Illinois Tollway Standard Drawings Revisions

Section L	Fiber Optic	
Standard	Modification Summary	Effective: 03-1-2022
L1-04	Fiber Optic System Typical and Drawings	
Sheet 1	Modified Note 3. Added "or compression coupled".

VERSION: 2022-03	STANDARD: L1-04	SHEET: 12 OF 15
---------------------	--------------------	--------------------

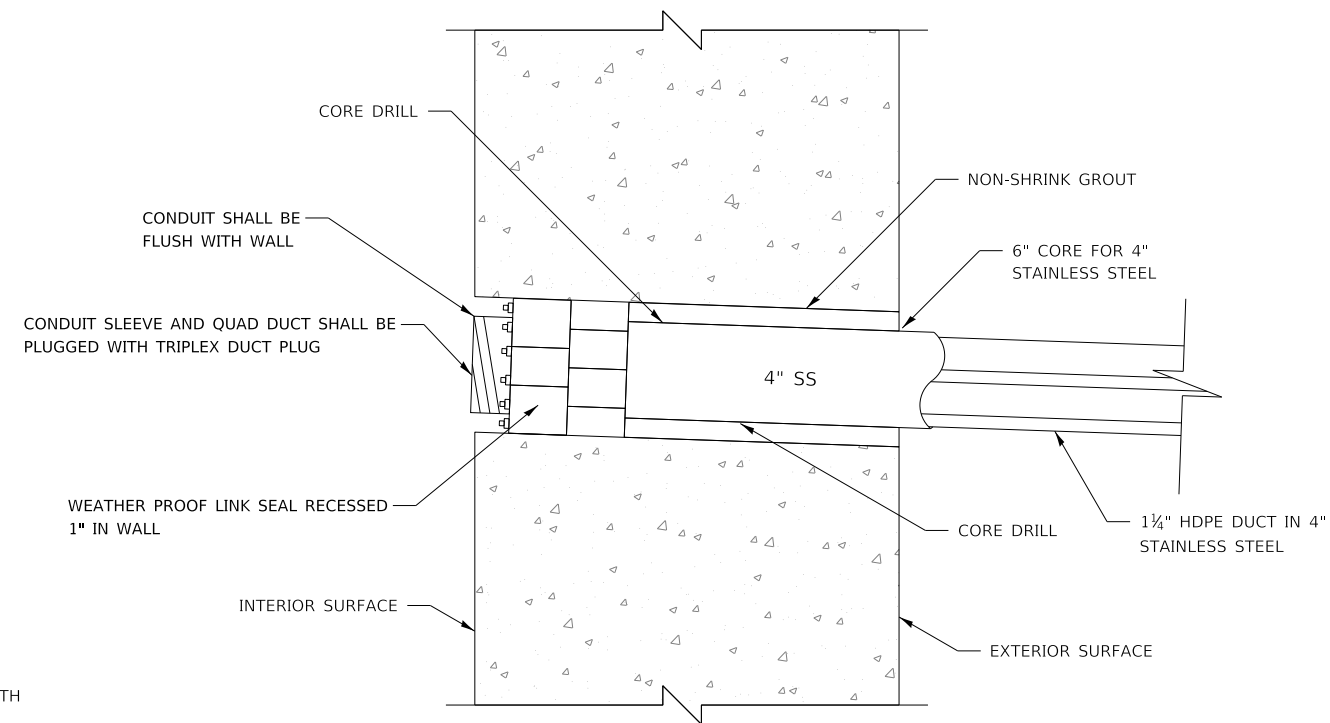
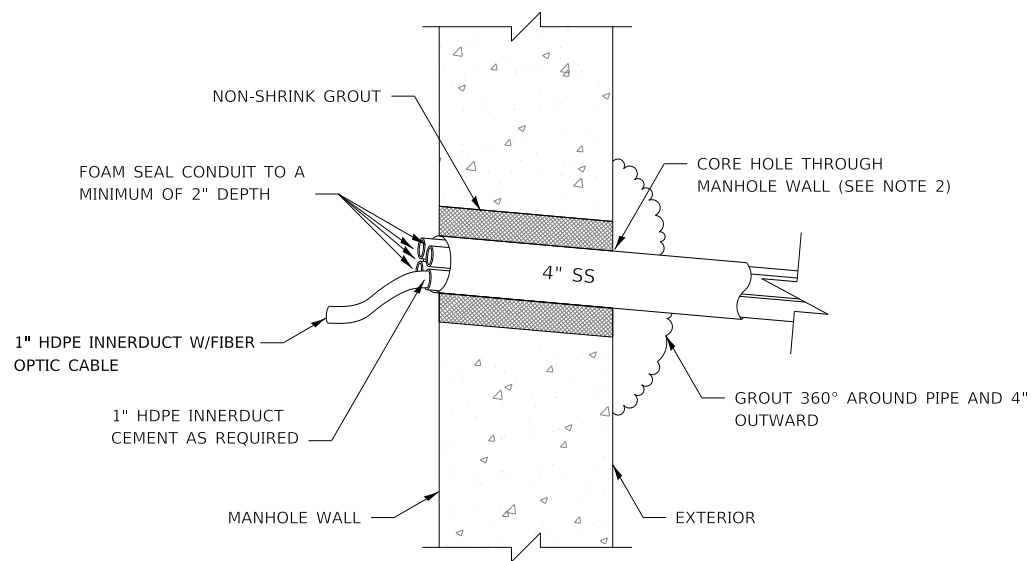
Sheet 12	Modified Note 1. Replaced "galvanized rigid steel" with "stainless steel".	
Sheet 12	Modified Detail "Below Grade Penetration Building". Replaced "galvanized rigid steel" with "stainless steel".	
L2-03	Fiber Optic Splicing Details

1. STAINLESS STEEL CONDUIT EXTENDING THROUGH FOUNDATION WALL SHALL BE ONE CONTINUOUS PIECE (NO COUPLINGS), SQUARE WITH BUILDING AT A SLIGHT ANGLE TO THE EXTERIOR TO PREVENT WATER SEEPAGE.
2. MANHOLE CORES SHALL NOT BE THROUGH MANHOLE CONE.

VERSION: 2022-03 STANDARD: L2-03 SHEET: 1 OF 2

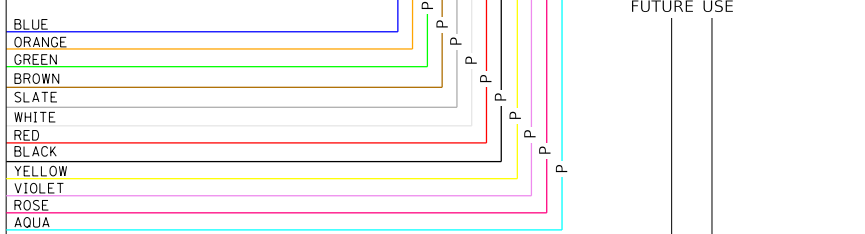
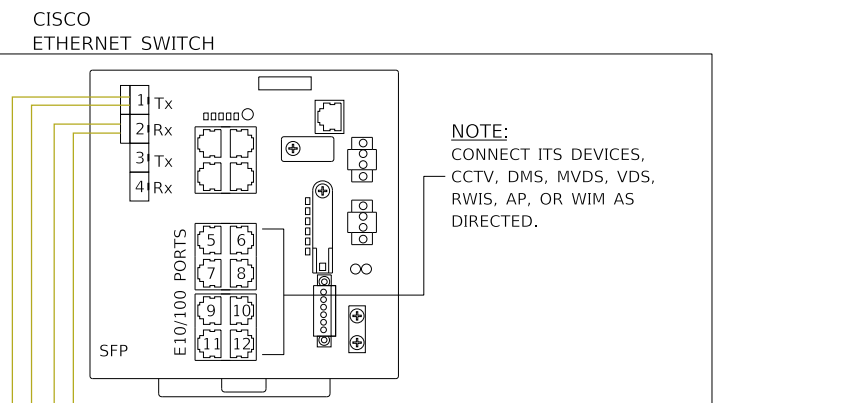
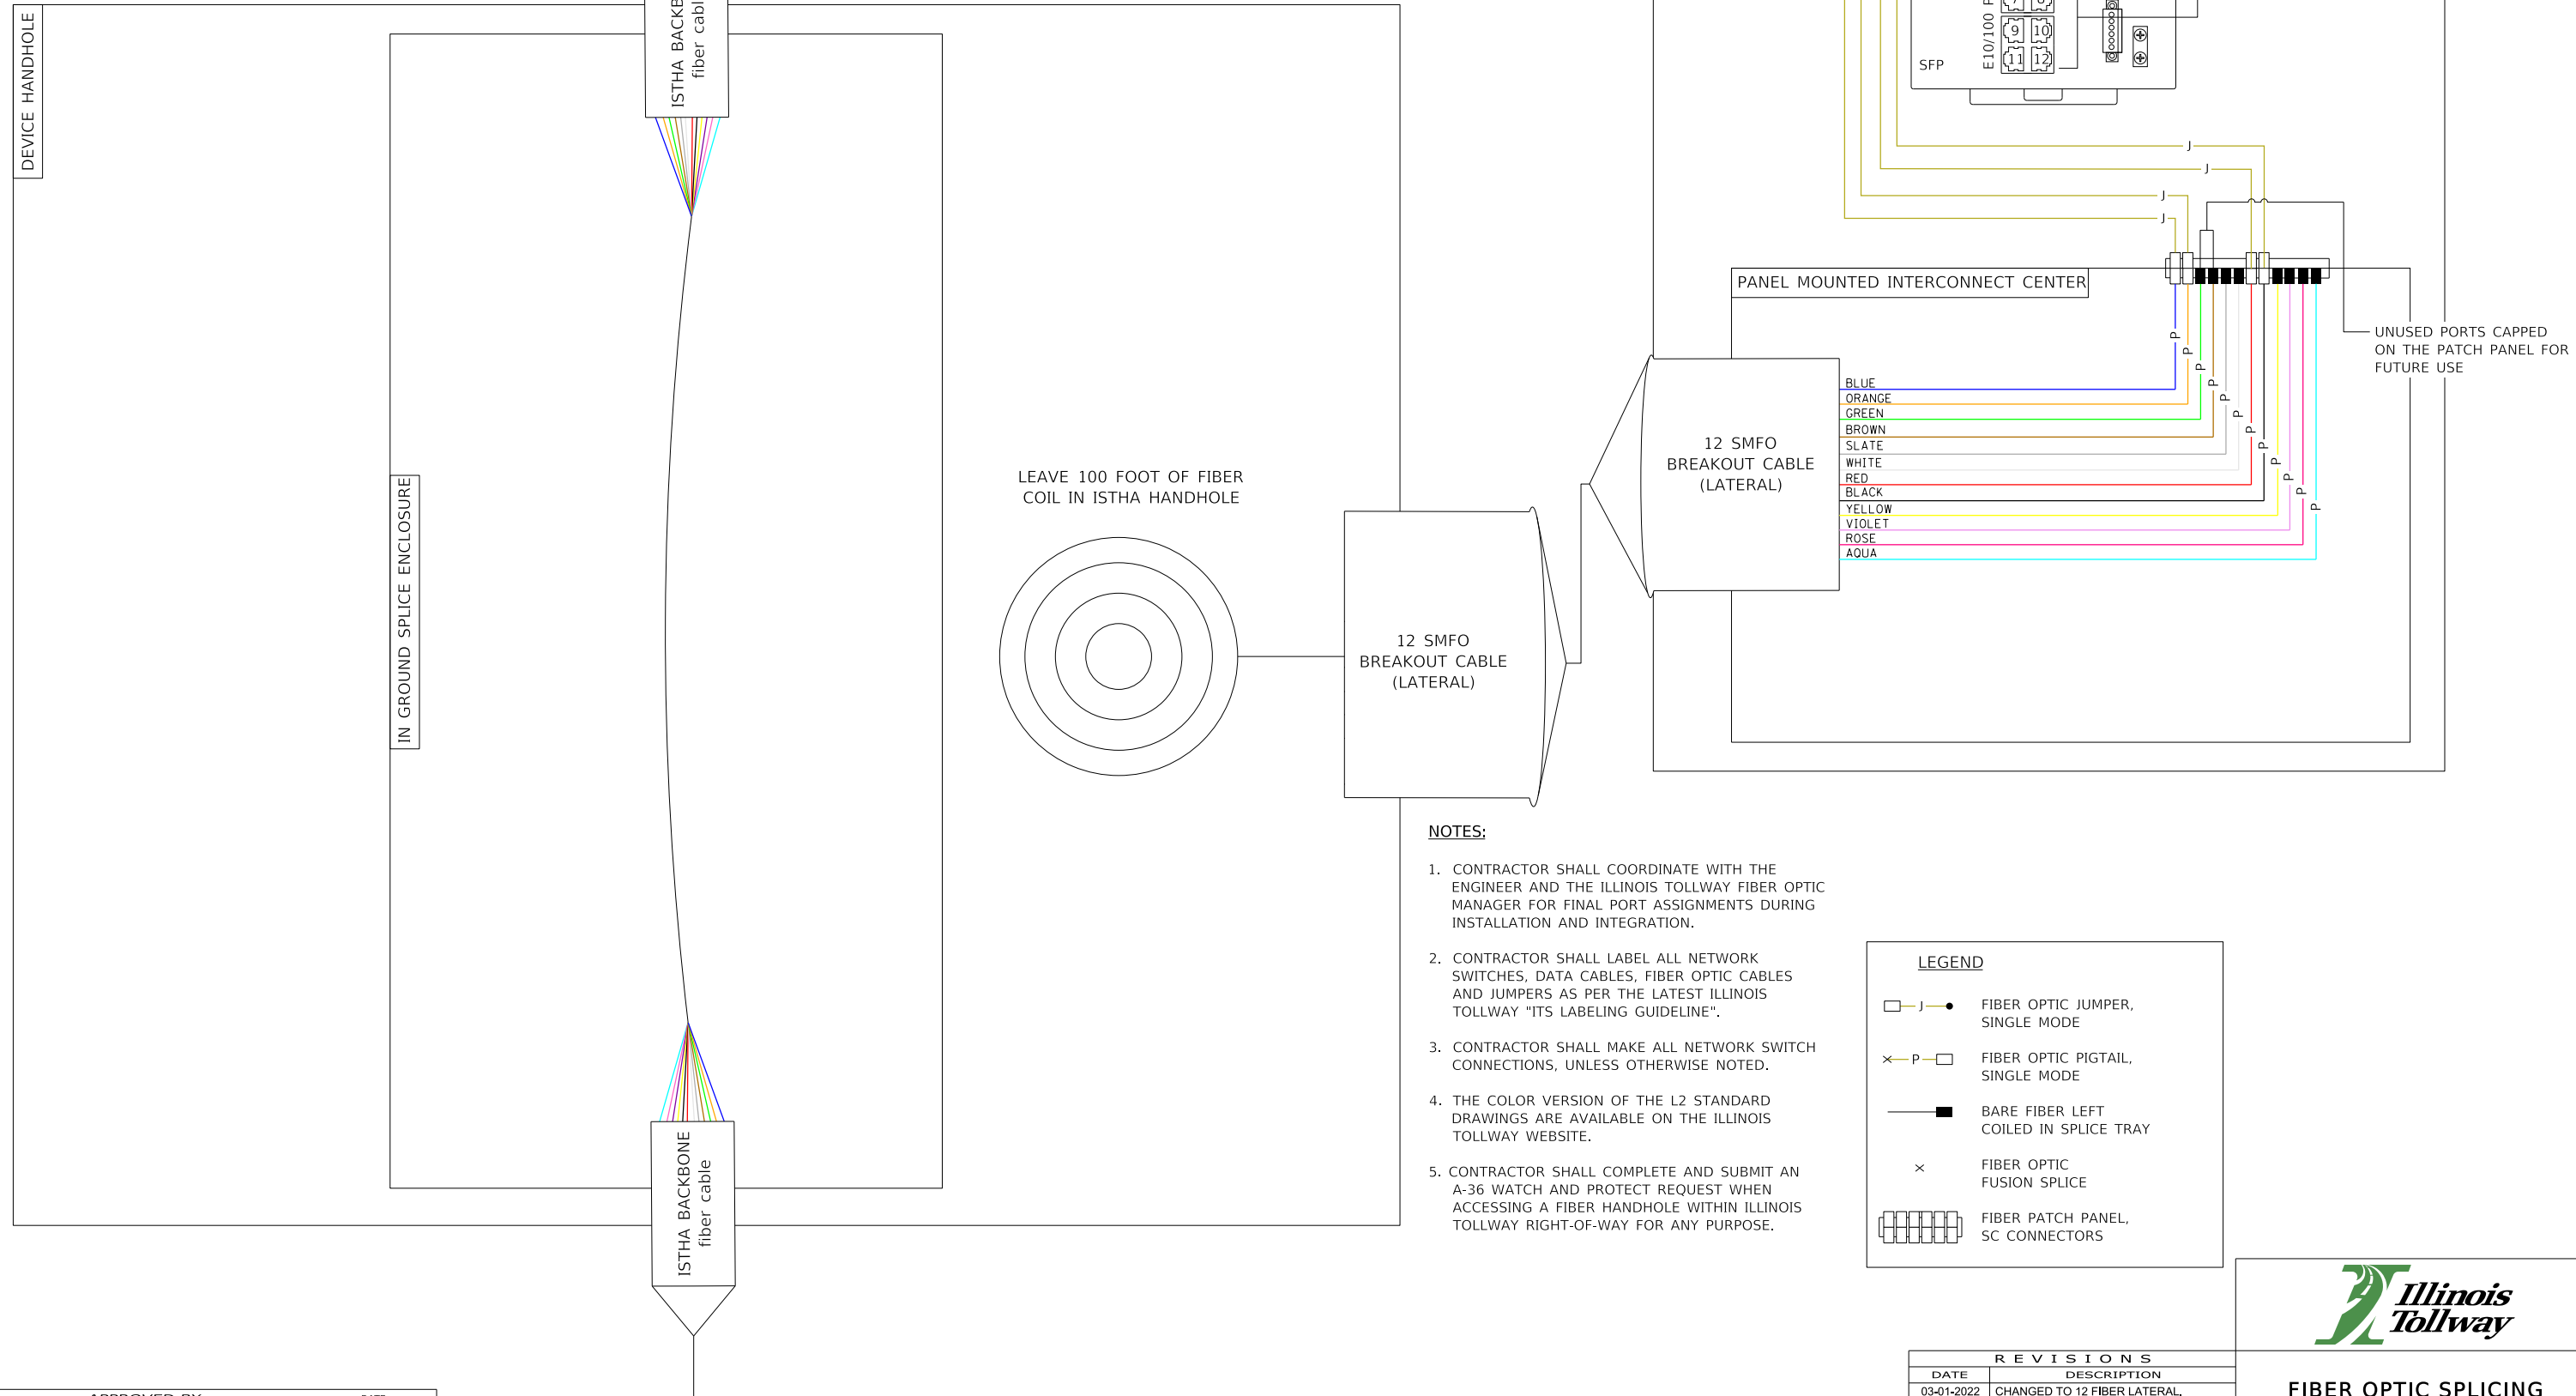
Sheet 1	Detail modified. Replaced the 8-port gator patch with a 12-port gator patch.	
Sheet 1	Detail modified. Updated the patch panel connections to reflect the 12 port gator patch.
